Minutes of a Planning Committee Meeting held at 7:15pm on Monday 2nd February 2026 in Bayston Hill Memorial Hall.

25/04875/OUT Outline planning application with all matters reserved (except for principal means of access), for development of up to 210 residential dwellings (Use Class C3) with associated open space, landscaping and other associated works including infrastructure, earthworks and drainage.
Proposed Residential Development To The North Of New Pulley Lane
Bayston Hill Shrewsbury Shropshire

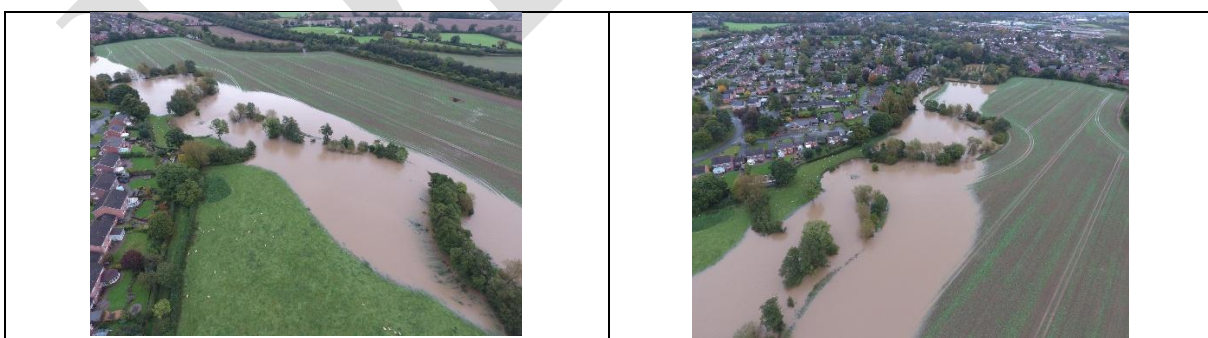
The majority of the proposed development site contains Grade 2 agricultural land, making it best and most versatile (BMV) in accordance with the Agricultural Land Classification.

Paragraph 187 of the NPPF requires that planning decisions recognise the wider benefits from natural capital and ecosystem services – including the economic and other benefits of the best and most versatile agricultural land, and Core strategy policy CS6 requires that **all development makes the most effective use of land and safeguards natural resources including high quality agricultural land.**

This land should continue to be used to provide food and not for housing which is not needed by the settlement of Bayston Hill.
